Architect's Supplemental Instructions (ASI's)

Project: Ellis Glen
Issue Date: August 22, 2024 (drawing dated August 22, 2024)
ASI No.: ASI- 01

ARCHITECT'S SUPPLEMENTAL INSTRUCTION NO: ASI- 01
CONTRACT FOR: Ellis Glen
ORIGINAL DRAWINGS DATED: 18 March 2024

The following plan changes were requested by the owner and made to the permit documents. These changes shall be incorporated:

UNIT C2 FLOOR PLANS

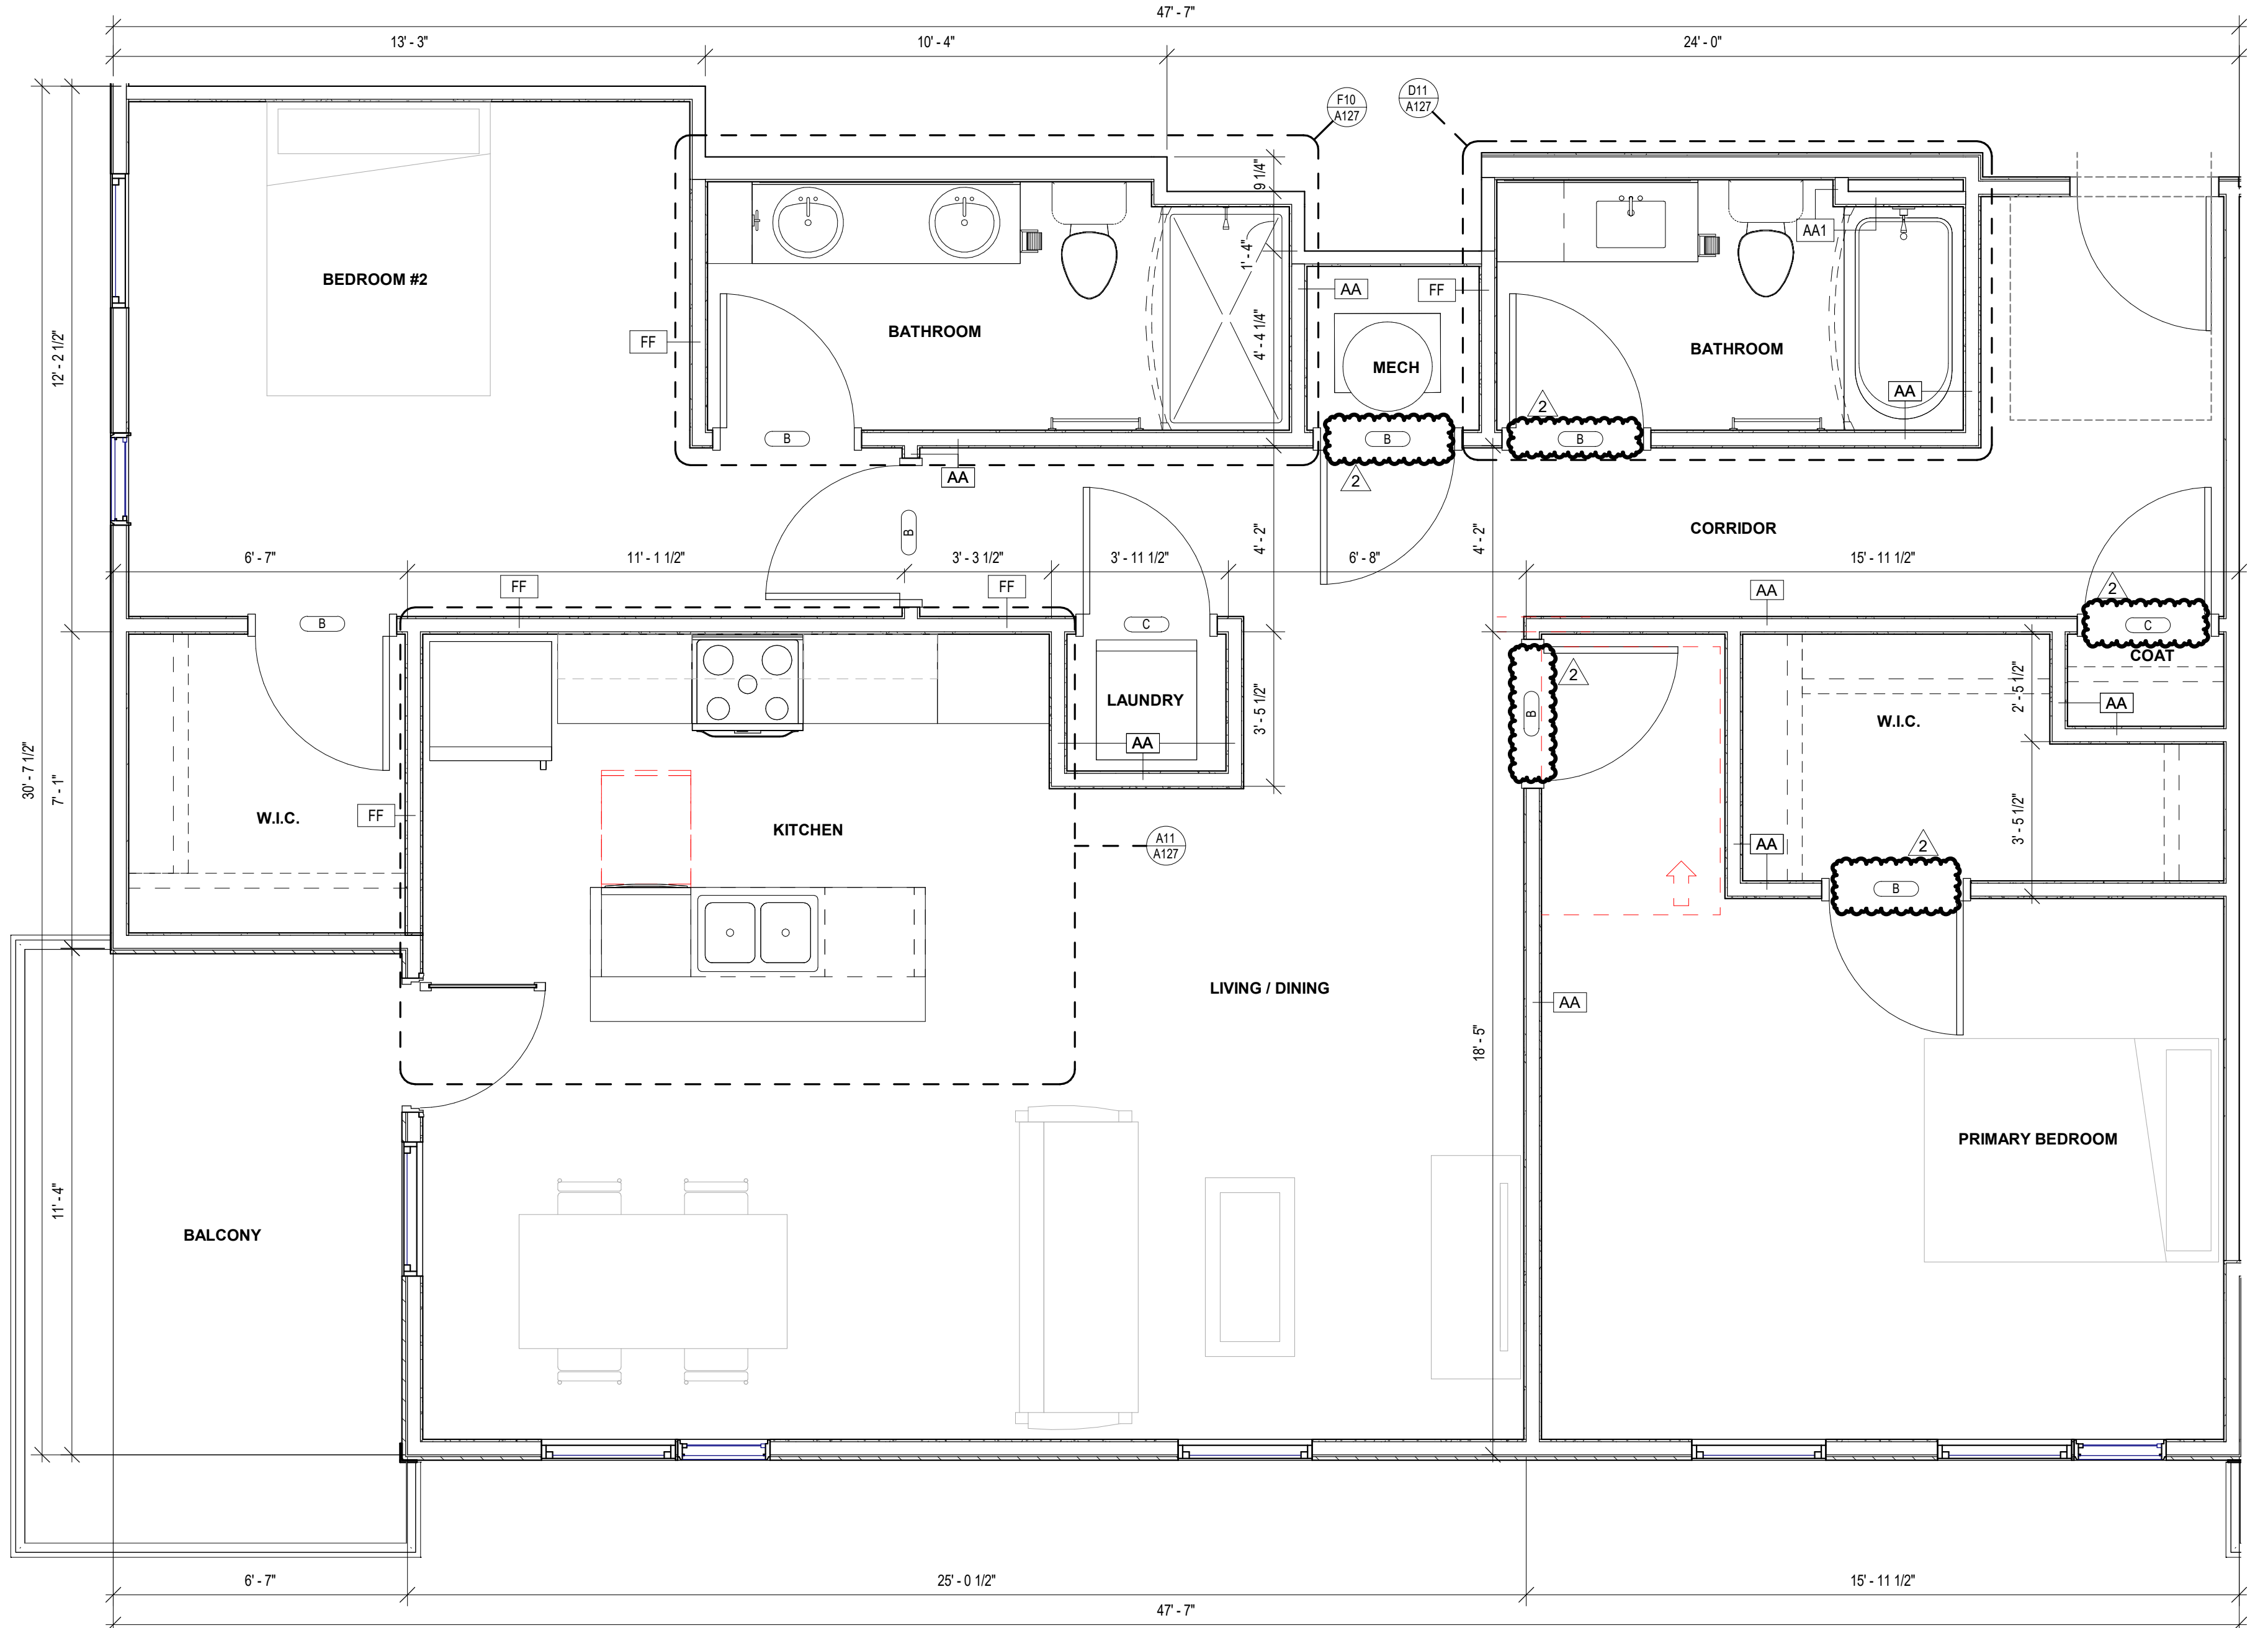
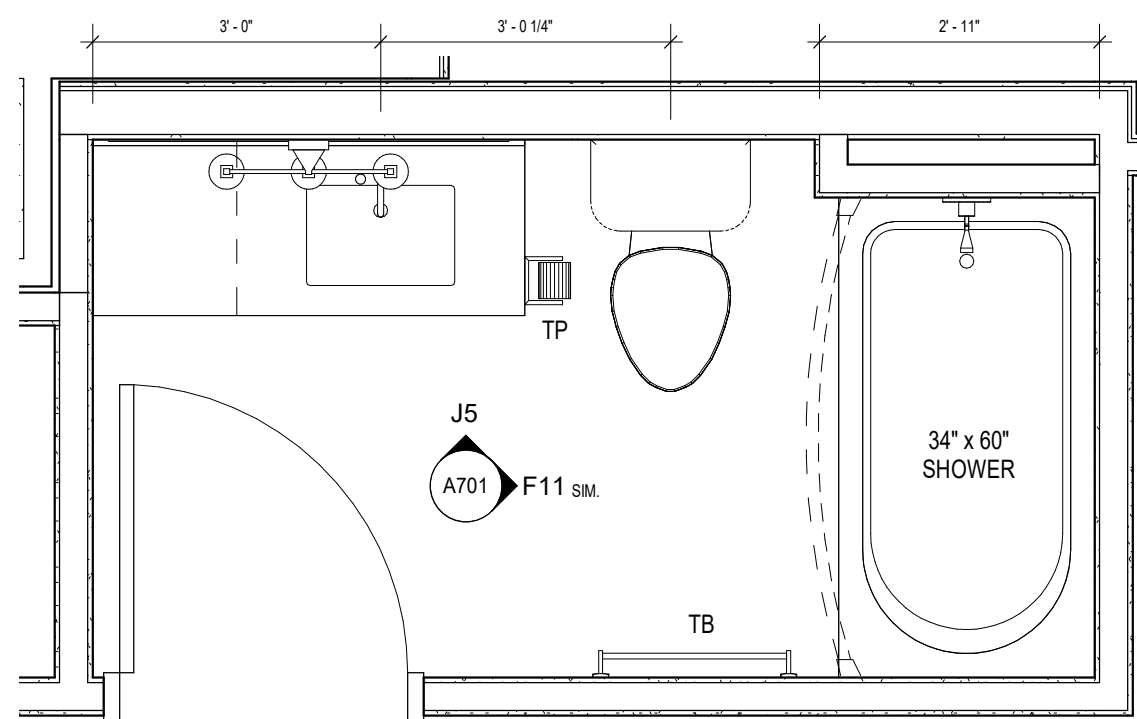
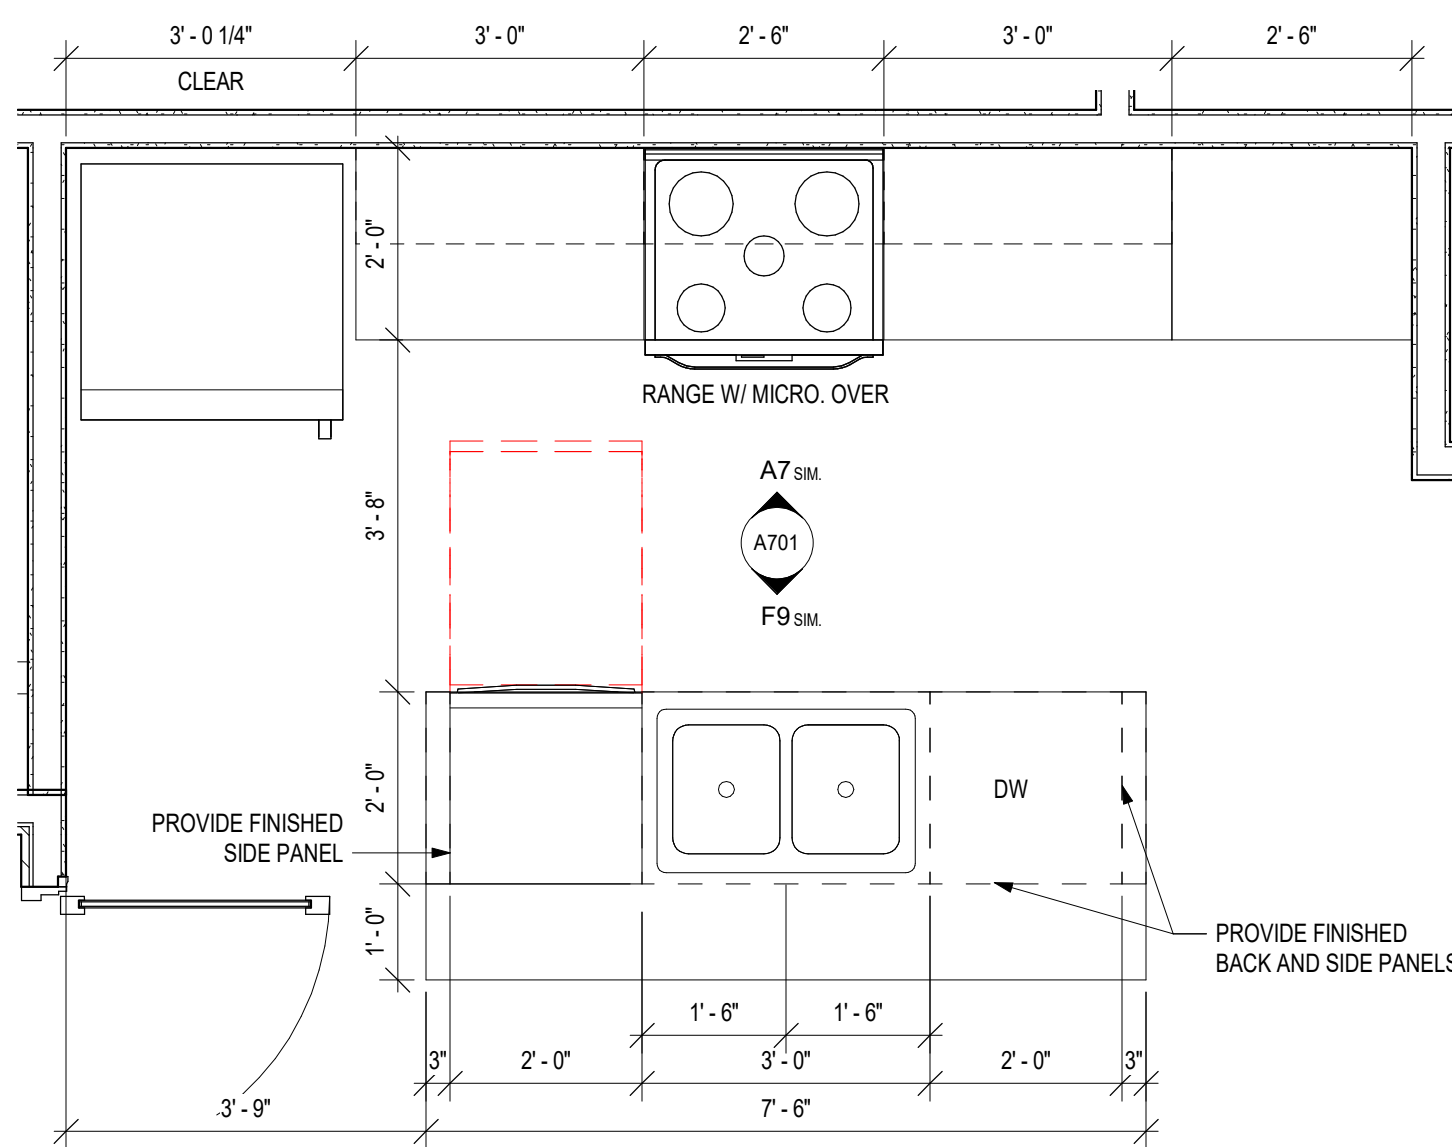
A124 and A127 – Units Plans for B3 and C2

1. Missing door tags were added to the plans.
